Access Compliance Report

Public Rights-of-Way

Intersection ID: 7478	Main Street: STONEHURST_DR	Cross Street: SULLINS_RD	Location:	N
ADA ID: 132864B01B59	Ramp Type: Perp	Initial Pass/Fail: Fail	Overall Compliance: No	Severity Score: 1.25
Codes/Mitigation Info/Possible Solution		Field Measurements/Component Compliance

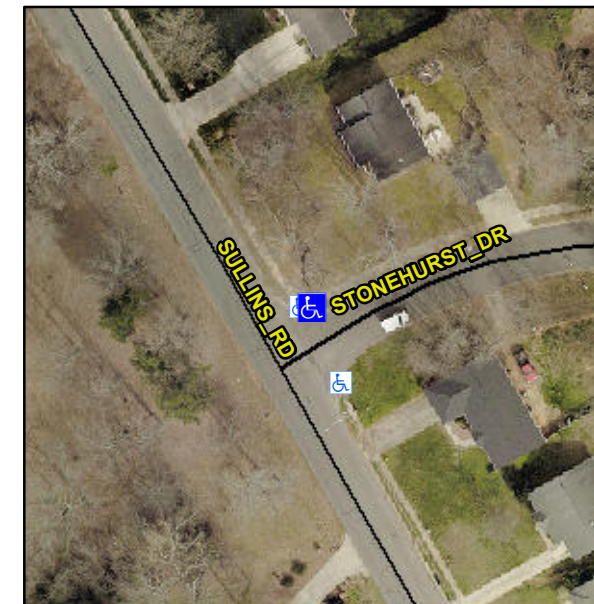
Not Found, R304.5.3

Compliance	Description	Data	Compliance	Description	Data
N/A	Ramp Length (in)	48.5	Yes	Ramp Slope (%)	7.2
Yes	Ramp Width (in)	48.0	No	Ramp XSlope (%)	4.3
N/A	Flare Type LT	N/A	N/A	Flare Type RT	N/A
N/A	Flare Slope LT (%)	N/A	N/A	Flare Slope RT (%)	N/A
N/A	Flare Traversable LT?	N/A	N/A	Flare Traversable RT?	N/A
N/A	Landing Length (in)	N/A	N/A	DWS Provided?	N/A
N/A	Landing Width (in)	N/A	N/A	DWS Contrast?	N/A
N/A	Landing Slope (%)	N/A	N/A	DWS Length (in)	N/A
N/A	Landing X Slope (%)	N/A	N/A	DWS Full Width?	N/A
N/A	Landing Curb? (Y/N)	N/A	N/A	DWS Offset (in)	N/A
N/A	Shared Landing?	N/A			
N/A	Gutter Ponding?	N/A	N/A	Gutter Slope (%)	N/A
N/A	Gutter Lip Ht (in)	N/A	N/A	Gutter X Slope (%)	N/A
N/A	Painted X Walk1?	No	N/A	Painted X Walk2?	N/A
	X Walk 1 Direction	To S		X Walk 2 Direction	N/A
N/A	X Walk 1 Width (in)	N/A	N/A	X Walk 2 Width (in)	N/A
	X Walk 1 Slope (%)	3.5		X Walk 2 Slope (%)	N/A
	X Walk 1 X Slope (%)	5.8		X Walk 2 X Slope (%)	N/A

Remove & Replace Entire Ramp.
